Advice to Macquarie River Food and Fibre on a literature review of the MDBA Northern Basin Review Science & Hydrological Reports

November 2016/Final Report

Barma Water Resource Consulting Pty Ltd

Figure 1. Comparison of Macquarie River Valley Specific Flow Indicators and Achievement Rates using the MDBA NBR Marshes Bucket Model (MDBA 2012).

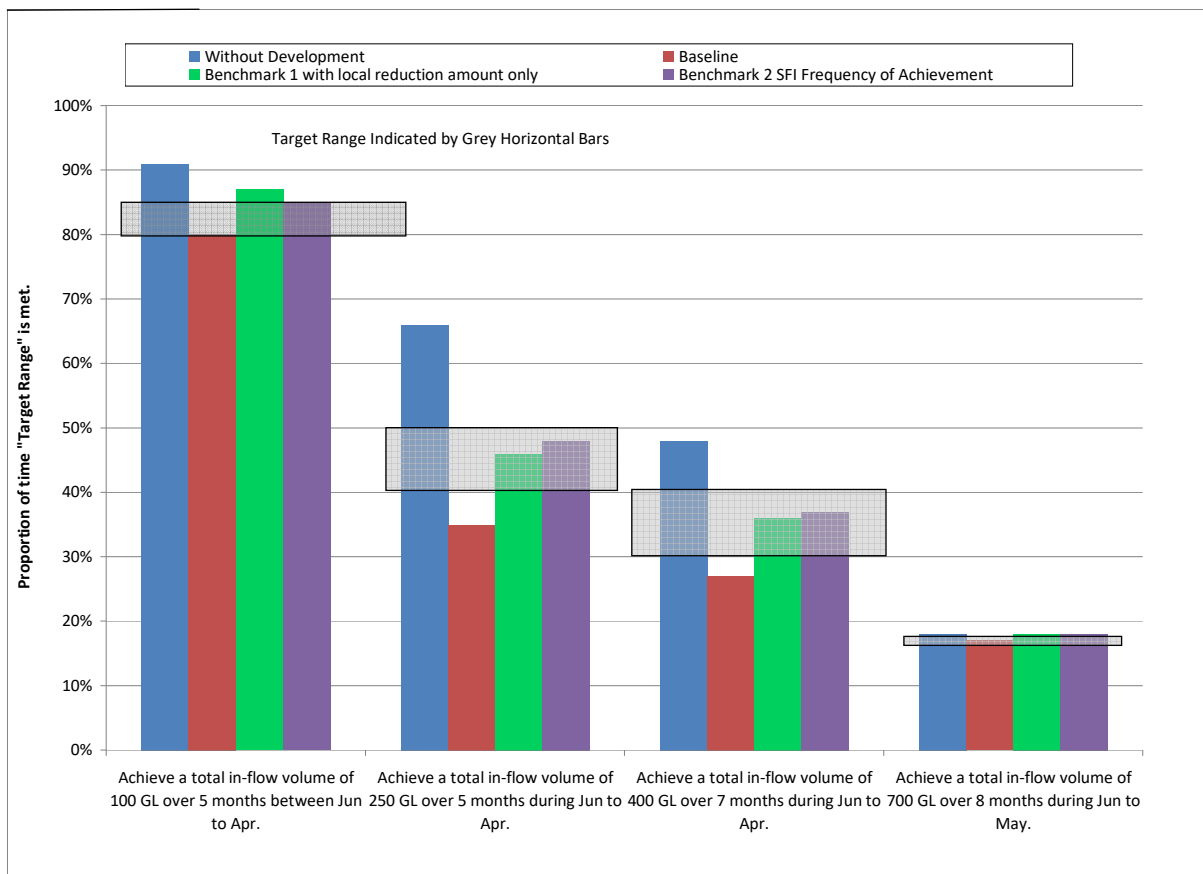
The achievement rates for the four SFI's in the Macquarie Valley indicate that two of the SFI's achieved the target range, and two were within 5% of the target range (Table 1, Figure 1) under the Baseline Scenario. This indicates that the Macquarie-Cudgegong Water Sharing Plan (DIPNR, 2004) (WSP) provided significant consideration to environmental requirements. If Benchmark 1, including only the local reduction target, without any additional recovery is included, the target range is met across all 4 SFI's.

This level of achievement exceeds the 2010 Basin Plan lower bound of the target range for all four of the SFIs. It is MRFF view that this indicates further water recovery requirements in the Macquarie Valley are not required, which is supported by the fact that only 15% of the total flow is extracted for production (Figure 2).

Figure 3 – Comparison of Old and New Model Diversions

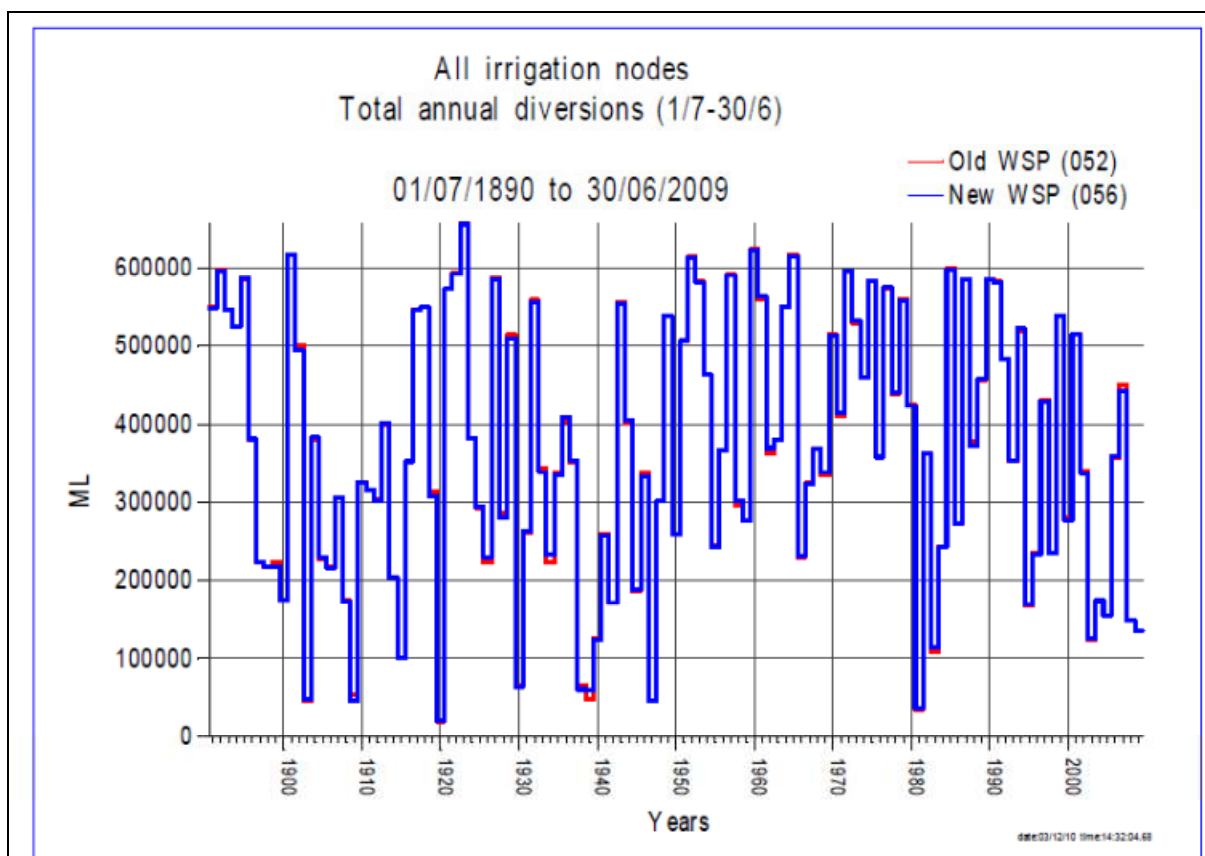
In 2014 NSW DPI Water provided a revised Macquarie IQQM to the MDBA. This model has a more detailed representation of the Macquarie Marshes and has been based upon a detailed hydrodynamic model of the marshes. Long term average diversions from the 2014 model were similar to that of the old 2009 model currently used by MDBA (Figure 3).

Whilst diversions from the two models are similar, the same cannot be said for end of system flows. The 2014 model (the **Detailed IQQM WSP Wetland Model**) produces end of system flow estimates some 40% lower than the NBR 2009 model (Table 2). Note: that flows at Marebone (Map 1) are lower for the new detailed model due to modelled Burrendong Inflows sequences being some ten percent lower than for the NBR model (Pers com DPIWater).

As outlined in the previous chapter there is a more contemporary Macquarie IQQM model that should be used for assessment as part of the NBR. **MRFF should consider asking MDBA to adopt this latest more detailed IQQM model.**

Figure 4. River flow data July to October 2015 during environmental watering event.

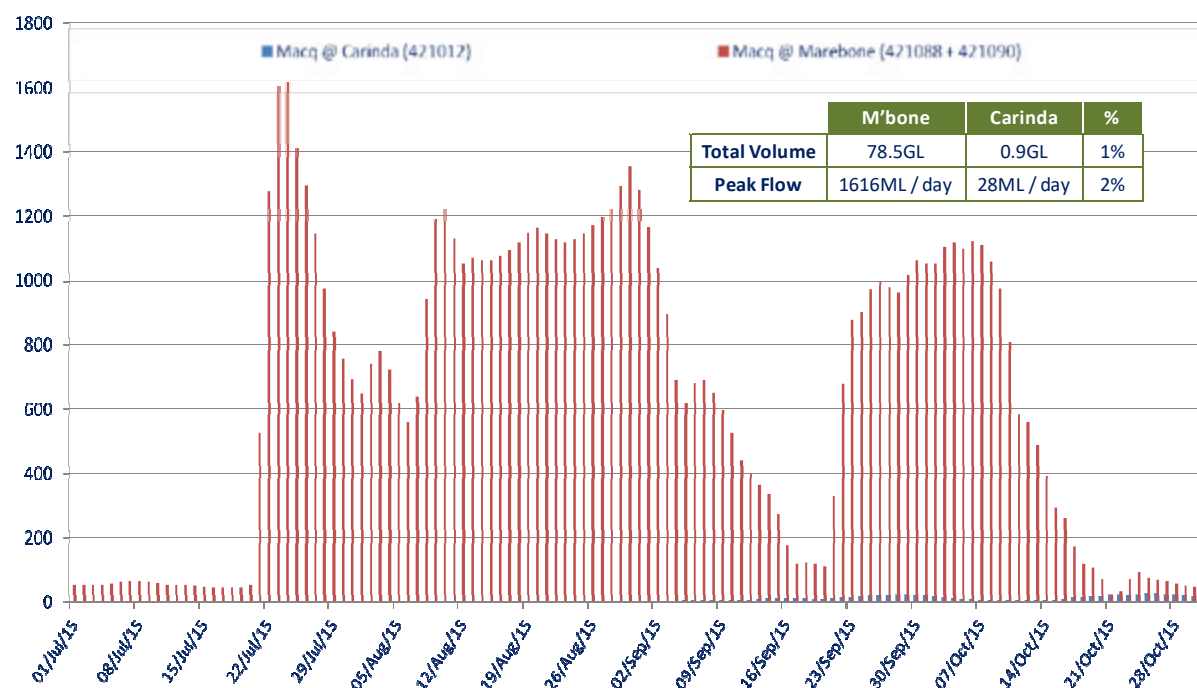
The start of environmental releases from Burrendong Dam in July 2015 arrived at Marebone on 21/7/2015 and the first rise was recorded at Carinda in early September some 6 weeks later (Figure 4). Similarly, the start of environmental releases in October 2013 reached Marebone around the 10th of October and a rise at Carinda arrived 4 weeks later (Figure 5).

Figure 6 – Comparison of Observed Flows at Marebone and Carinda with those produced by the Detailed Wetland Model April 1986 to April 2015.

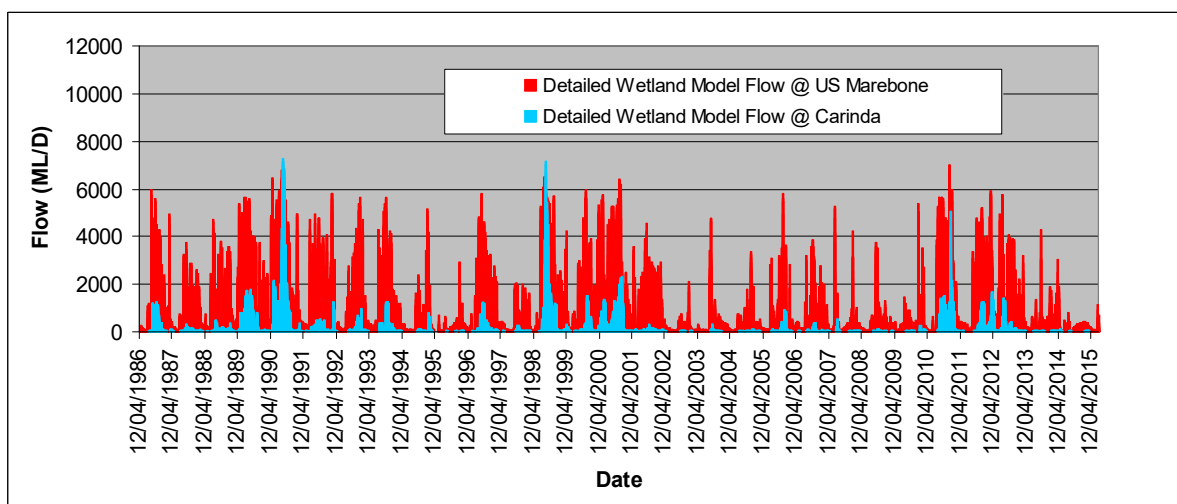
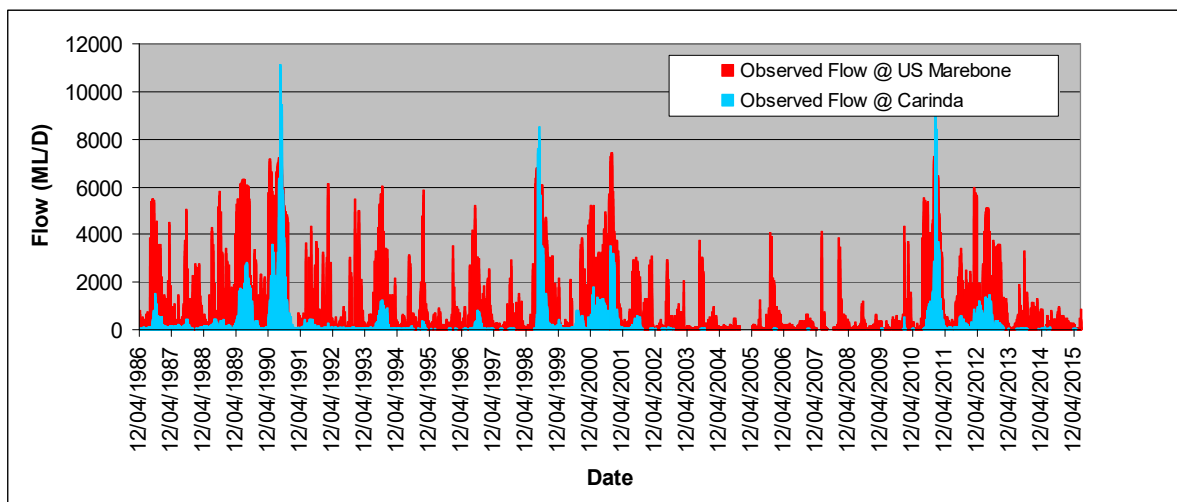
The 2014 Detailed Wetland Model illustrates that larger outflows at Carinda are produced by flood type events that occur at Marebone, whilst smaller regulated events produce very small outflows. This relationship closely reflects observed outflows (Figure 6 and Figure 7); indicating the 2014 Detailed Wetland Model is a superior model to the 2009 NBR Bucket Model for the purpose of understanding the Macquarie system.

Figure 8. Comparison of fall in elevation against distance from Bourke for Major Rivers in the Northern Murray Darling Basin.

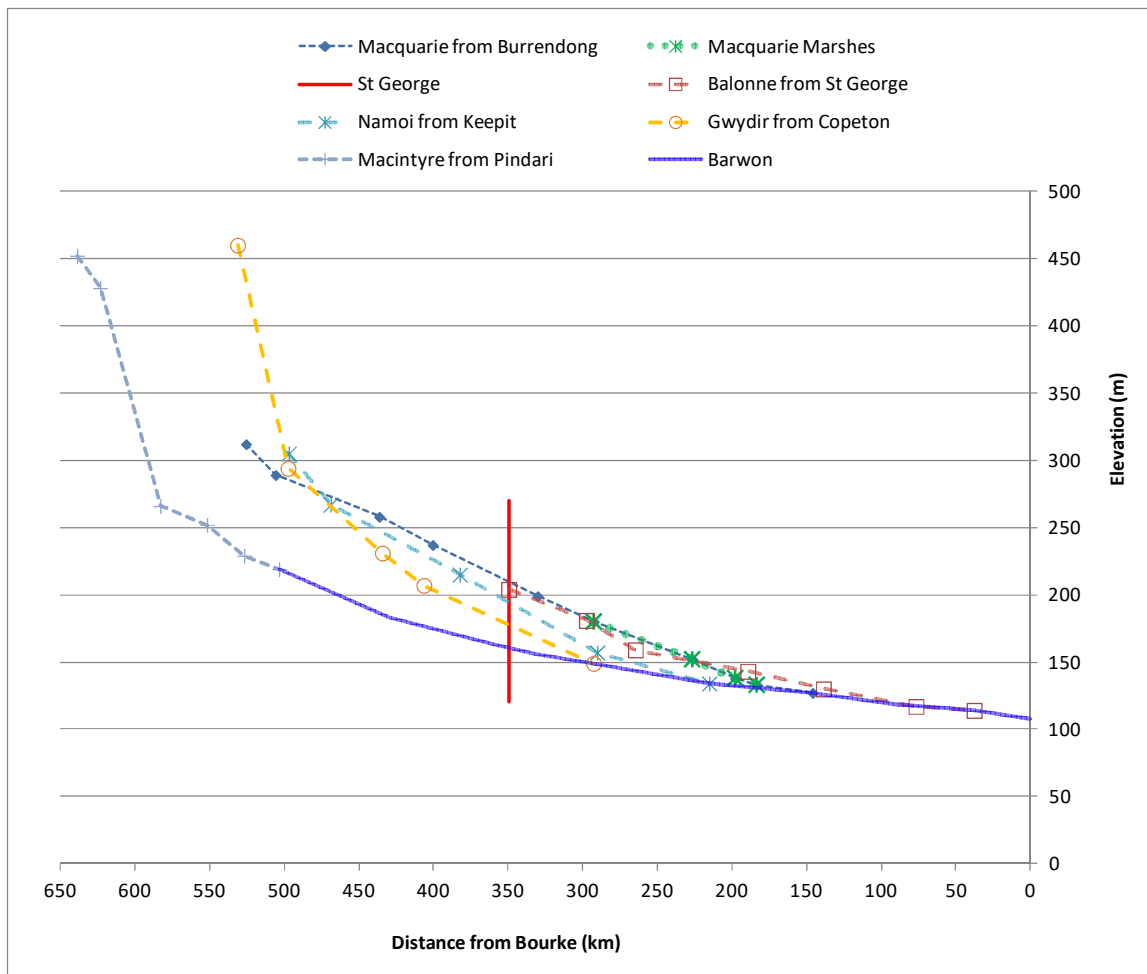
The Linked Time Demand Series modelling assumes that water can be released from storages in the Northern Basin including Burrendong Dam and be linked to trigger flows at St George in the Condamine/Balonne system when these flows reach the Darling River near Bourke. MRFF and BRW Pty Ltd believe this assumption to be incorrect as all of the contributing rivers have further to travel and have less fall in their last 350 km than does the Condamine/Culgoa system (Figure 8). MRFF have stated that they have requested a copy of the modelling and assumptions from the MDBA and that they have not been provided to date. However, given the material supplied by the MDBA to BWR Pty Ltd and the details provided in the MDBA's Hydrologic Modelling Report to Inform the Basin Plan, BWR Pty Ltd is satisfied that the methodology behind the modelling has been explained in sufficient detail for the purposes of this review.

Further throttling the capacity of the Macquarie system to provide end of system flows is delivery constrictions along the river and for environmental flows to not create any third party impacts. The maximum flow at Marebone must not exceed 3,100 ML/day (Sri Sritharan, pers comm.) to avoid overbank losses, and just downstream at Oxley once flows exceed 900 ML/day water breaks out the Oxley Break further reducing flows into the Marshes.
